## **REMARKS**

Applicant(s): FEINER, David      Examiner: NGHIEM, M.  
 Serial No.: 09/982,985      Group Art Unit: 2863  
 Filed: October 22, 2001  
 Title: APPARATUS AND METHOD FOR PROTECTING PRINTING HEADS

**CORRECTED DRAWINGS**

A corrected version of Fig. 1 is enclosed herein.

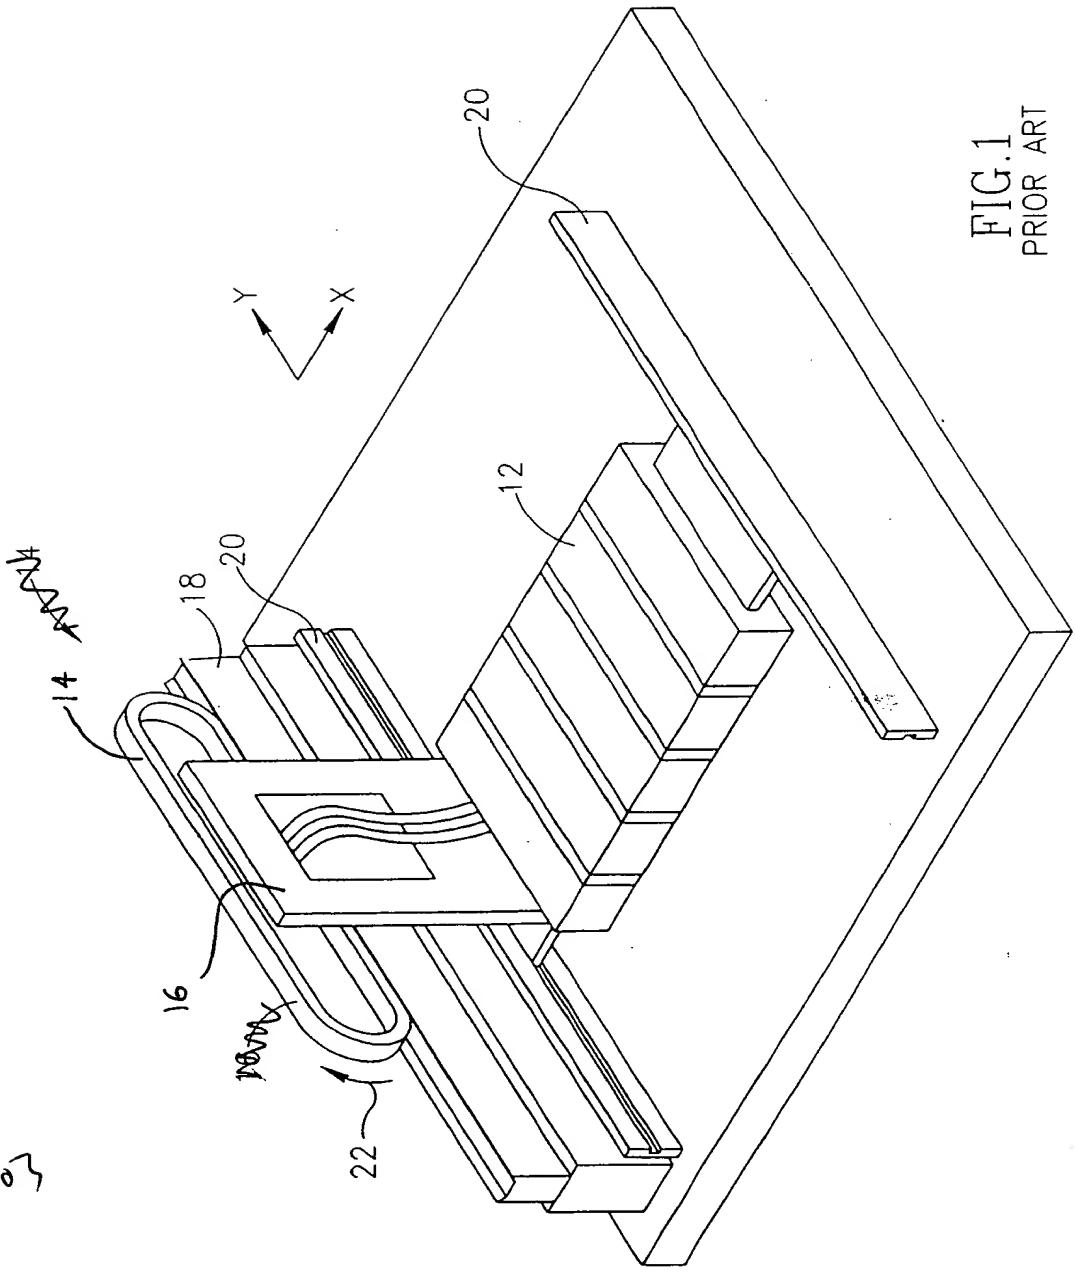
The drawings were objected to as failing to comply with 37 CFR 1.84(p) (5) because they include reference number "20" of Fig. 1, which is not described in the specification. Applicant has amended the specification to include reference numeral "20".

The drawings were objected to because reference number "16" of Fig. 1 is not pointing to the right element. Applicant has amended Fig. 1. Approval is requested.

For a reference to anticipate a claim, the reference must teach all elements of the claim. Applicant asserts that Admitted Prior Art of Fig. 1 does not teach all elements of claims 2 and 3. In the Office Action, the Examiner contends that component 20 of Fig. 1 is attachable to the movable component 16. This is not true, as movable component 16 is rigidly coupled to the flexible cable carrier at one end, and to the print head 12 at the other end. Print head 12 moves along linear bearing 20, which is not attachable to movable component 16.

The amendments to the Specification are editorial in nature. In particular, the reference numeral "20" of Figure 1, which was not described in the specification has been added to the description of Fig. 1. No new matter has been added.
